August 29, 2006

L-2006-199
10 CFR 50.4

RE: St. Lucie Unit 2
Docket No. 50-389
Response to Request for Additional Information on
SL2-15 Steam Generator Inspection Reports

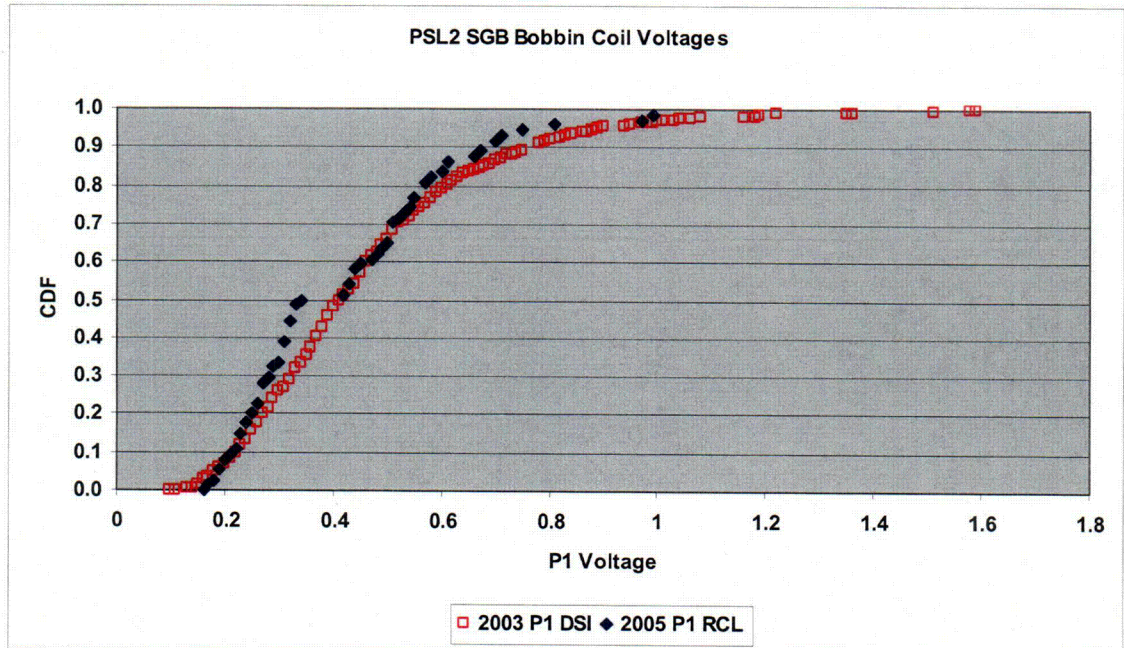
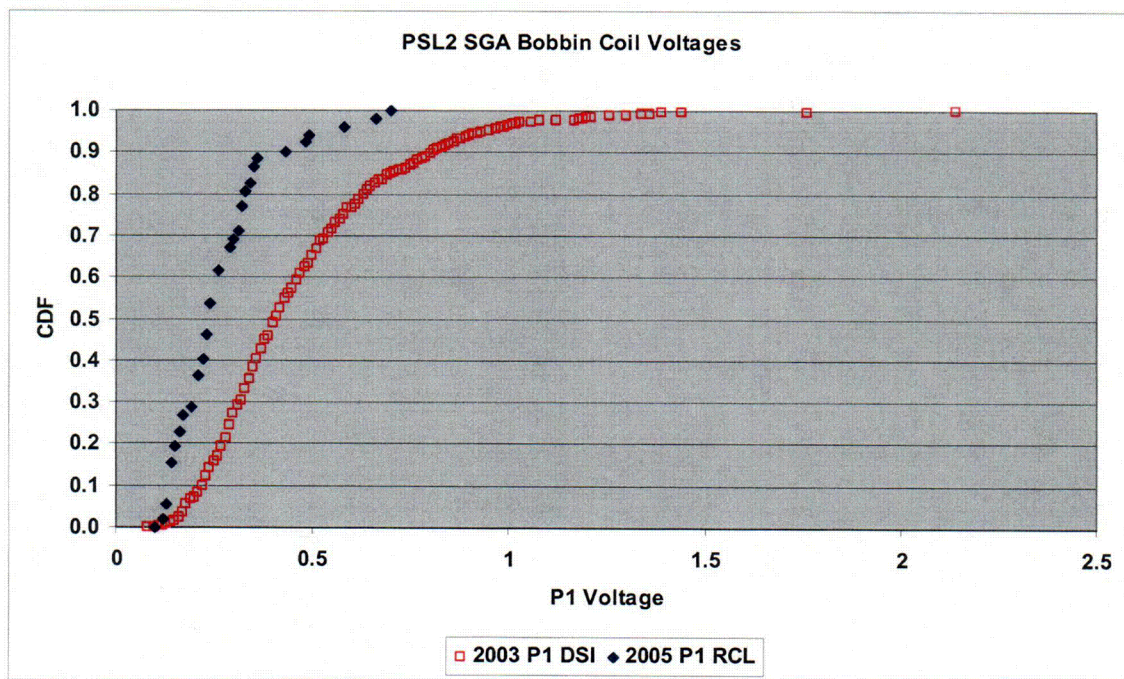
Observation a. - The RCL indications were attributed to probability of detection associated with the bobbin coil. Rather than comparing the outcome of the multicycle computer algorithm to the depth/voltage of the RCLs in making this determination, a more direct comparison may be to look at the bobbin voltage associated with the 2005 RCLs and compare it to the 2003 bobbin voltage associated with the 2005 confirmed DSIs. The distributions should be similar. Since the bobbin data is used to determine the growth rates (based on look-back analysis) such an analysis should be consistent with the growth rate methodology.

Reply to Observation a. - Comparison of voltages for 2005 RCL bobbin coil indications and 2003 bobbin coil associated with 2005 confirmed DSI indications are shown in the following 2 figures. Note that the bobbin coil voltages for the 2005 RCL indications fall to the left of the look back bobbin coil voltages (i.e., 2003 voltage) for the confirmed DSI indications identified in 2005. The smaller voltages for the RCLs supports the probability of detection used in the OPCON model for axial ODSCC eggcrate degradation.

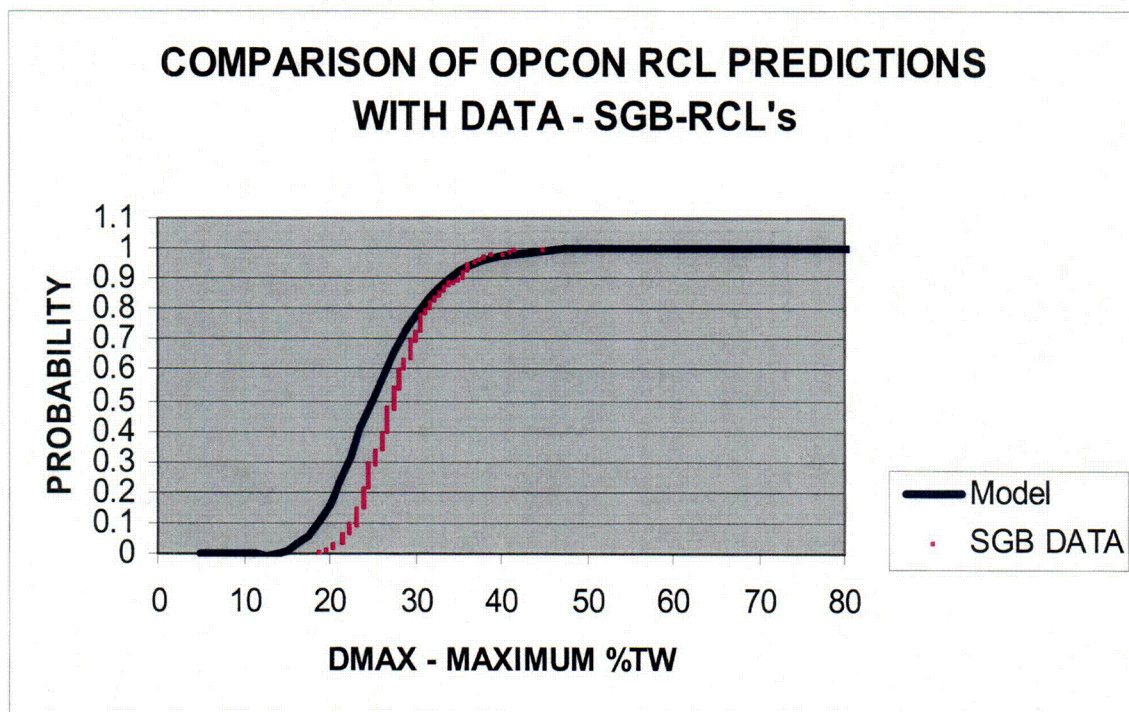
Observation b. - For probabilistic analysis, both the number of indications and the size of the indications are important. The number of RCLs/DSIs should also be consistent with your models. If the number of RCLs is larger than expected (i.e., the undetected population is underpredicted), additional inspections may be needed in 2005 to ensure condition monitoring limits are met in 2005 and for justifying a full cycle of operation.

Reply to Observation b. – A comparison between observed RCL's and OPCON model predictions for the 2005 outage is shown in the figure below. The depth distribution for RCL's predicted by OPCON agrees well with the data, particularly in the more critical upper region. The estimated number of RCL's predicted by the model is approximately 220. This is somewhat conservative by comparison with the 200 observed in the 2005 outage for SG-B. The 220 flaws predicted by the model are based on a limited inspection corresponding to the number of 2005 DSI pull-out scans.

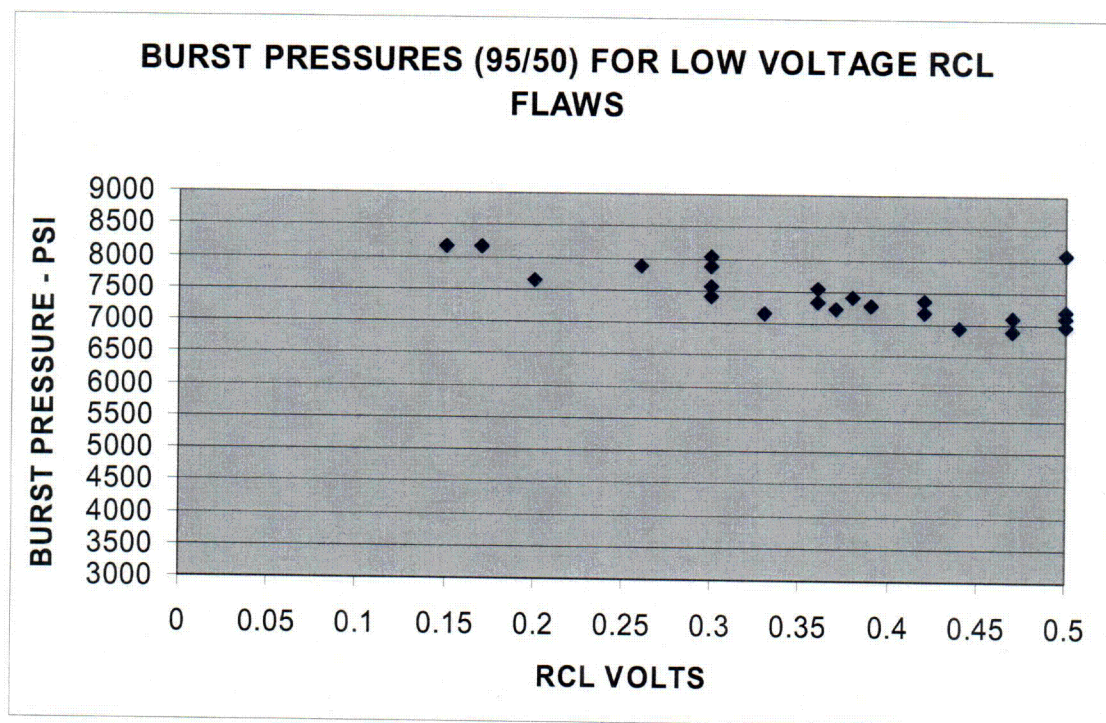
Observation e. - To confirm the adequacy of the screening criteria for determining when RCLs should be inspected with a qualified technique, it would be useful to look at the burst pressures associated with the RCLs to see if they support the 0.35 volt screening criteria (i.e., do any of the lower voltage RCLs have low burst pressures).

Reply to Observation e. - Computed burst pressures for lower voltage RCL's are shown in the following figure. It can be clearly seen from the figure that RCL's with voltages less than 0.35 volts do not challenge the structural limit.

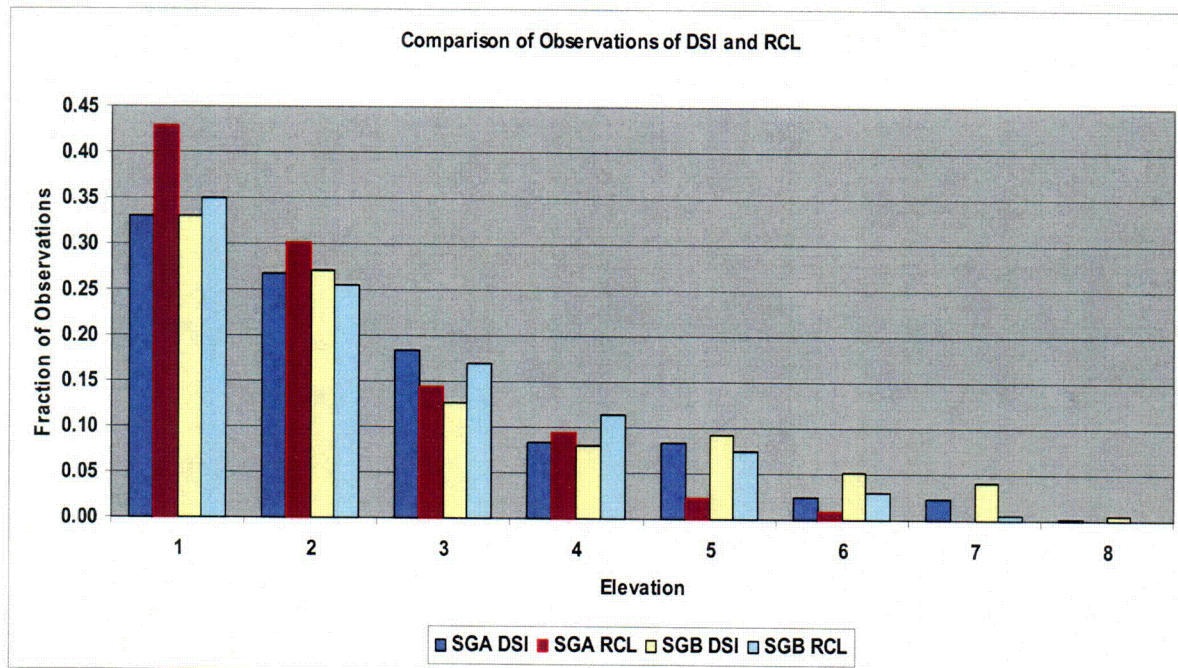
Observation f. - If the RCLs are a result of the probability of bobbin coil detection, then it should be confirmed that the distribution of RCL indications at various tube support elevations are consistent with the distribution of DSIs.

Reply to Observation f. - The frequency of occurrence of DSI and RCL per elevation are shown in the following figure. Note that the distributions are quite similar, reinforcing the impact of the Probability of Detection function.
